W. Apparels Chancellor Garments Ltd.

295/JA/4 Rayer Bazar, Dhaka
(23.74143N, 90.36202E)
08 March 2014

Observations

**Columns appear to be stressed in excess of
normal design limits**

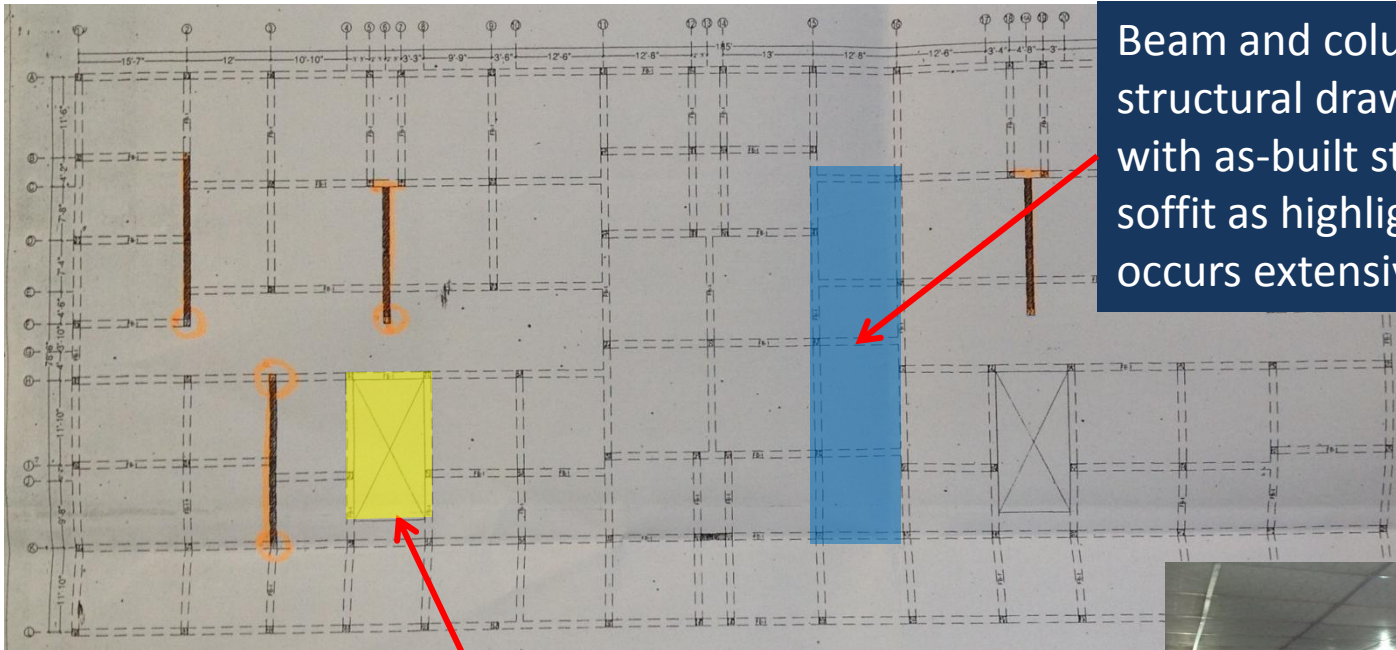
Cursory calculations indicate that column working stress is in excess of normal design limits.

Building Engineer is to perform detailed calculations including a Detail Engineering Assessment (See attached scope) and concrete tests to prove column size and (if required):

- Reduce loads by vacating floors
- Reinforce columns

**Structural drawings not consistent with the
as-constructed arrangement of the factory**

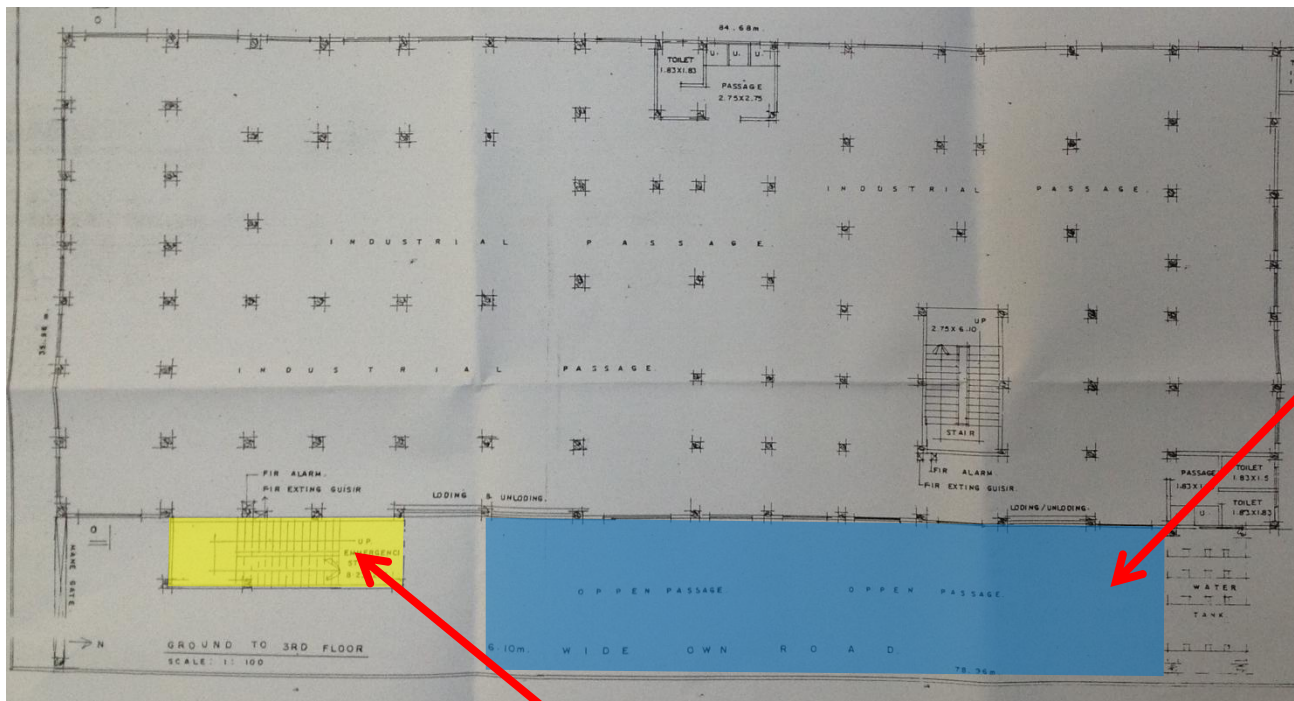
Beam and column arrangement on structural drawings not consistent with as-built structure on 2nd floor soffit as highlighted. Discrepancy also occurs extensively on 1st floor soffit.

Stair ope in-filled

4th floor column layout differs from Ground to 3rd floor column layout

The building structure should be surveyed and a set of accurate “As-Built” drawings prepared consistent with the current structural arrangement

Steel stairs and lean-to structures

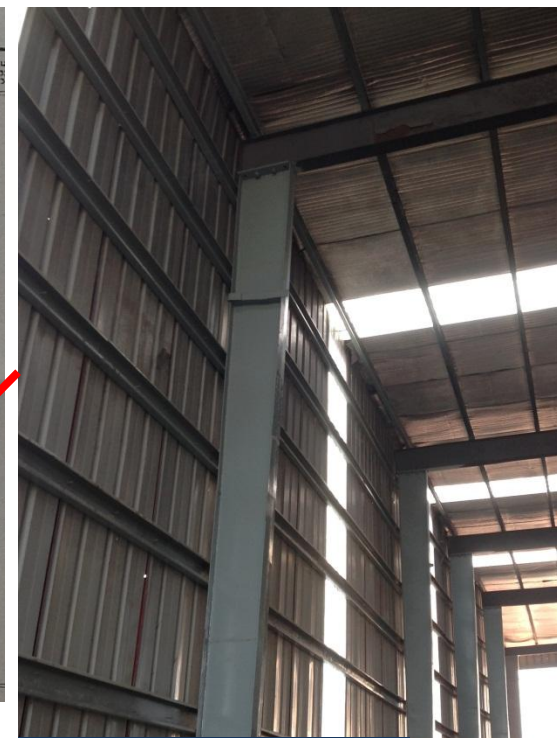
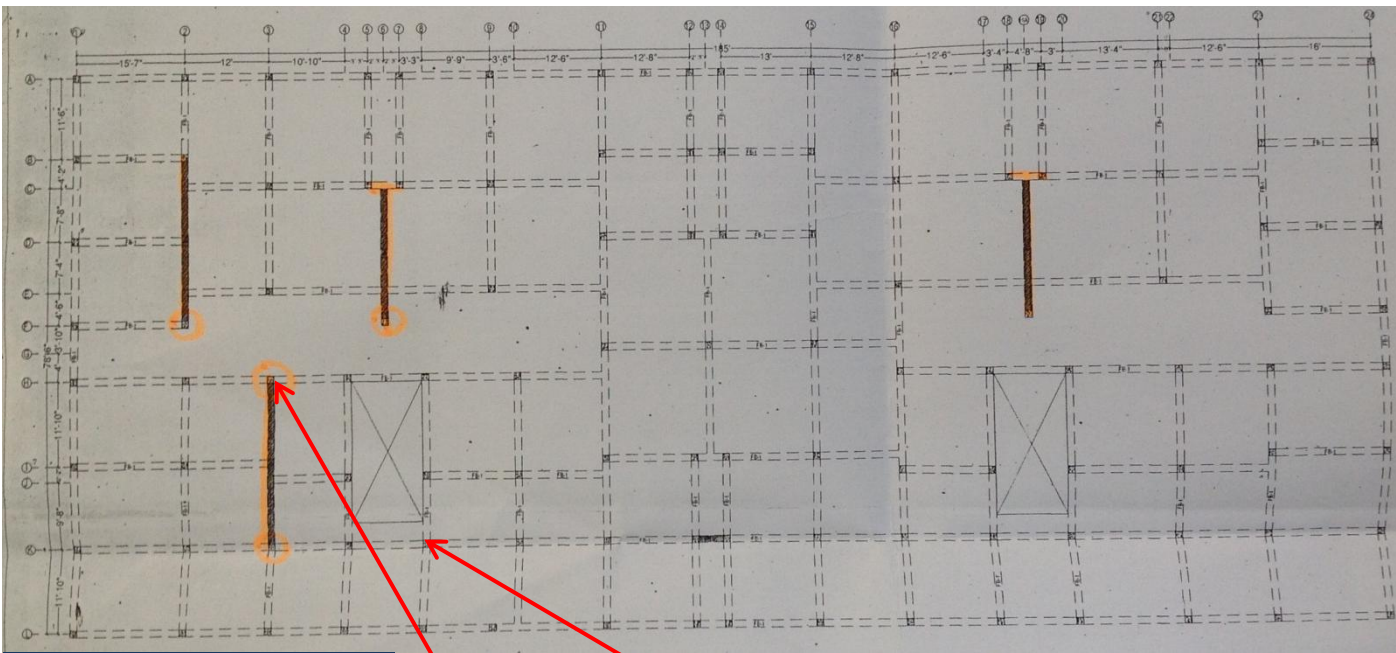
Check required to confirm that steel frame to lean-to entrance structure and steel stairs is adequately braced and designed to resist high wind loading and that connections are adequately designed and confirmed to be as-built

Additional steel stairs and lean-to structure not on structural drawings.

Engineer to check design of steel structures to resist high wind and lateral loads and completeness of connections on site.

Cracking of columns and slabs

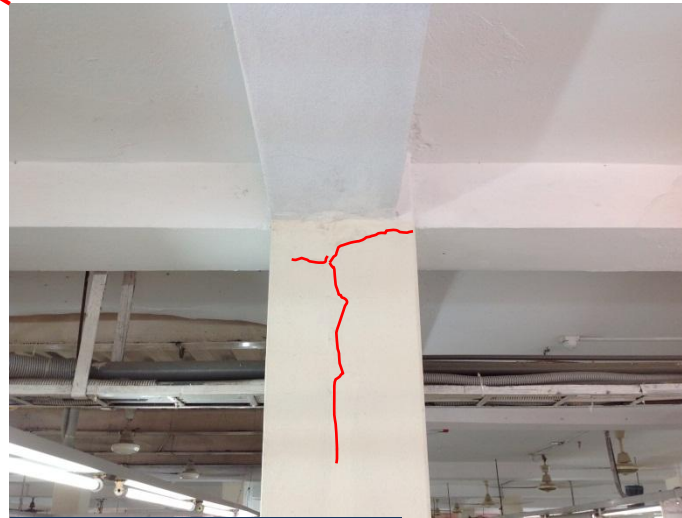
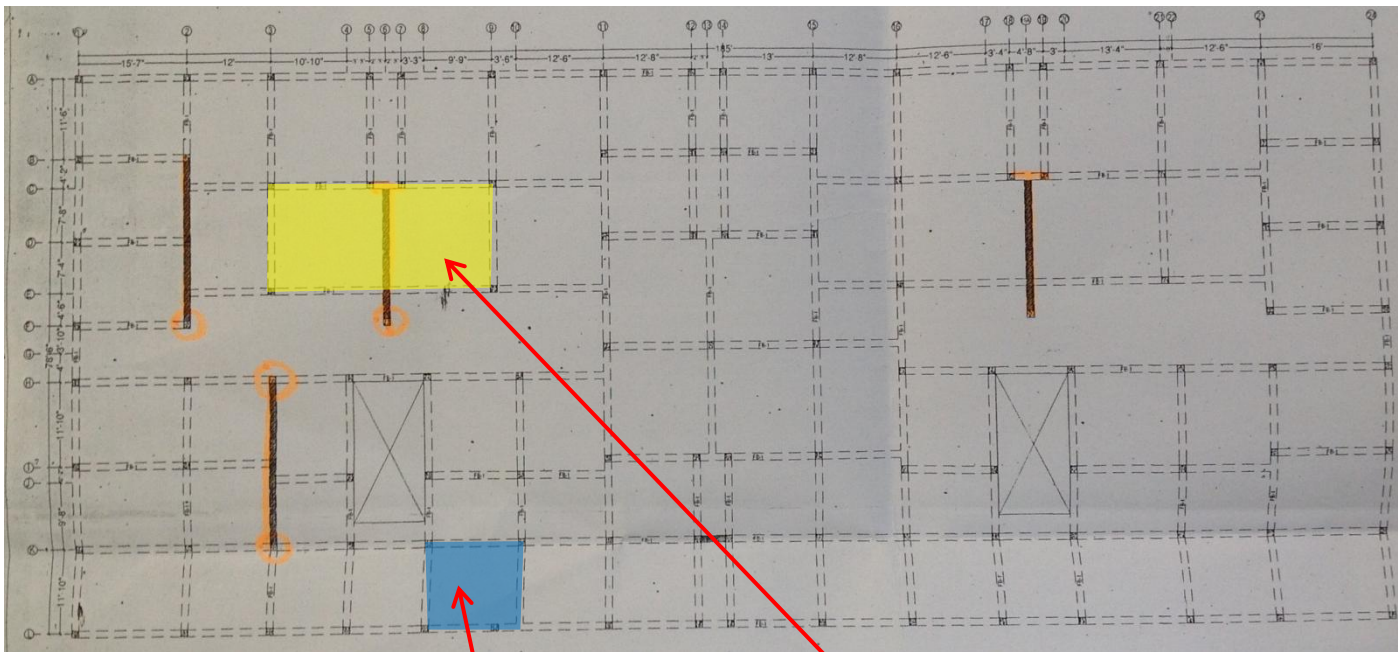
Cracking of 2 No columns on 3rd floor and cracking on the soffit of 3rd and 4th floor slabs

Column cracks to be reviewed by removing plaster to confirm that cracks do not extend into structure.

Cracking of columns and slabs

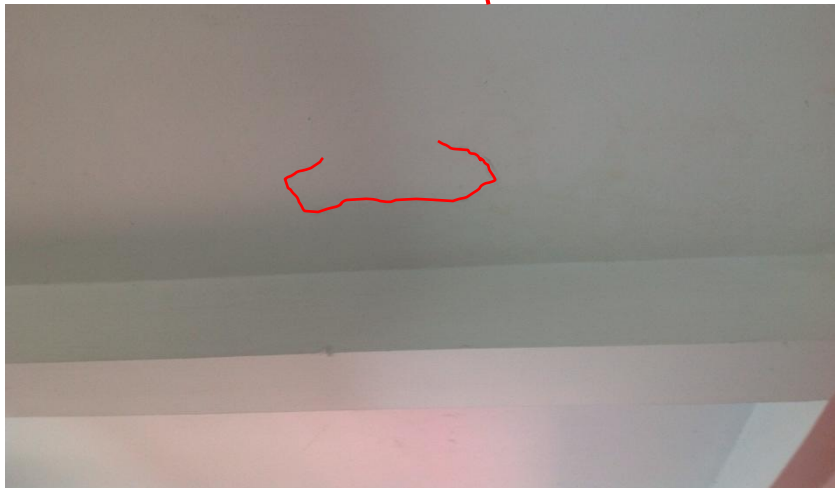
3rd Floor crack in slab soffit

2nd Floor crack in slab soffit

Beam and slab cracks to be reviewed by removing plaster to confirm that cracks do not extend into structure.

Management of floor loads

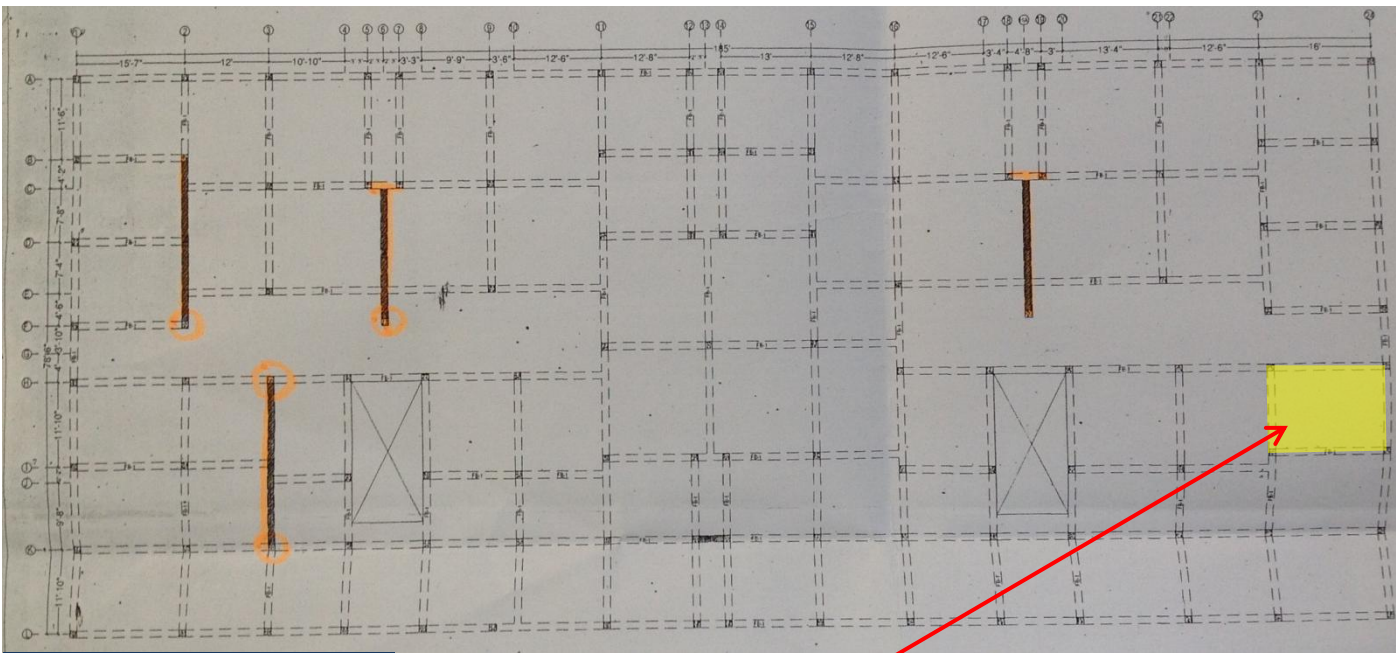
Management of loads on 3rd floor

3rd Floor storage area

Building Engineer to create controlled loading plans for all floors which will designate where storage can be placed.

Cracking of downstand beams

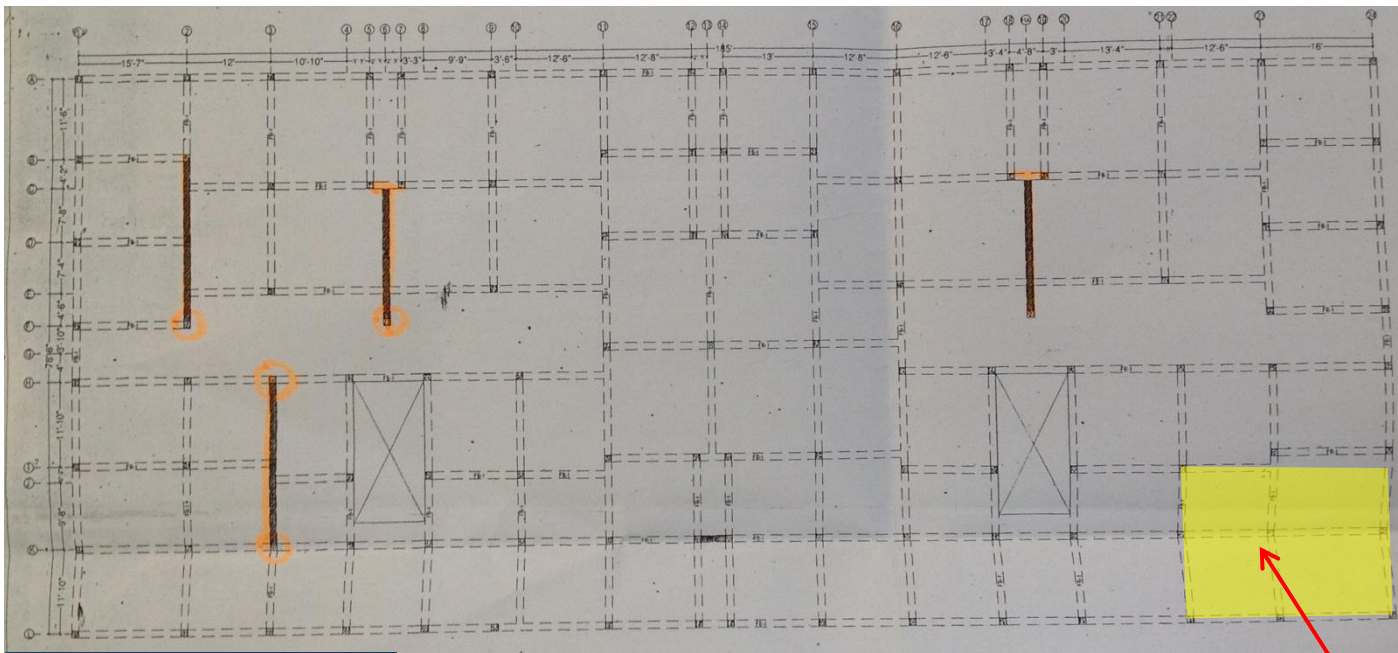
Cracking of beams on soffit of all floors

Beam cracks on all floors to be reviewed by removing plaster to confirm that cracks do not extend into structure.

Floor build-up design check

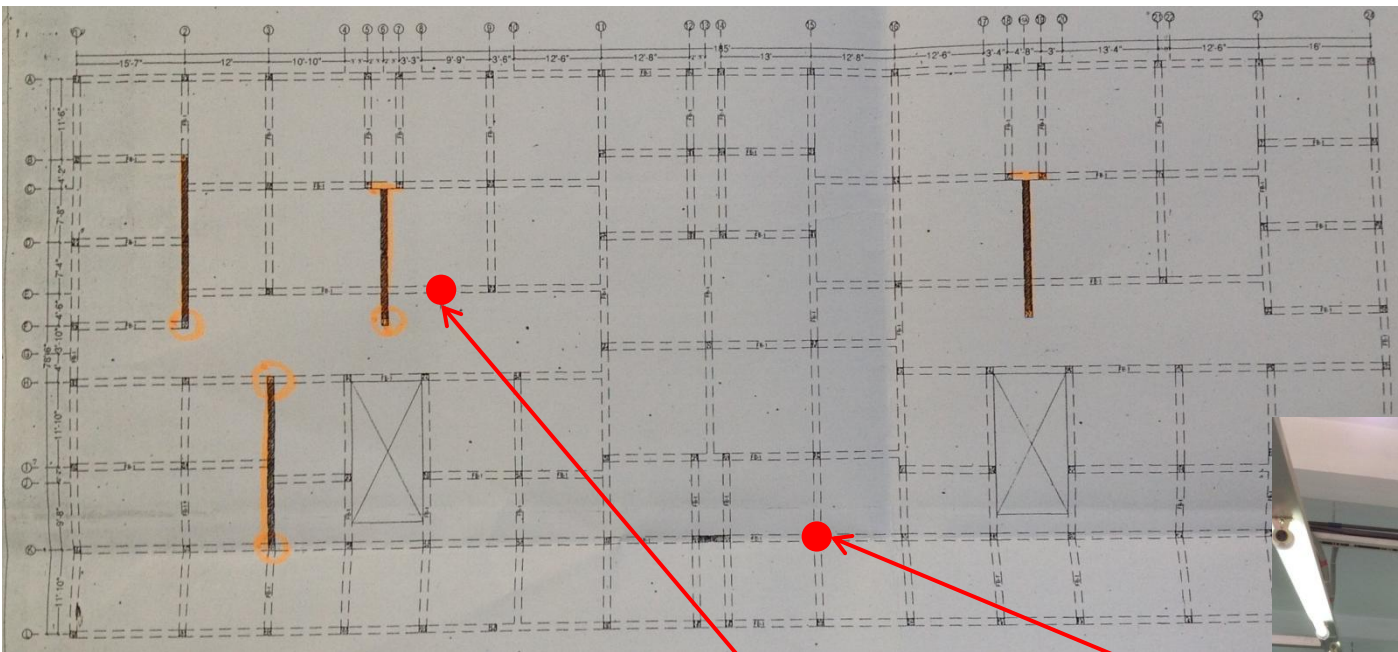
Design check required for floor build-up in toilet area on 3rd floor to confirm floor slab load capacity

Building Engineer to review and confirm floor slab load capacity to carry floor build-up loading in toilet area.
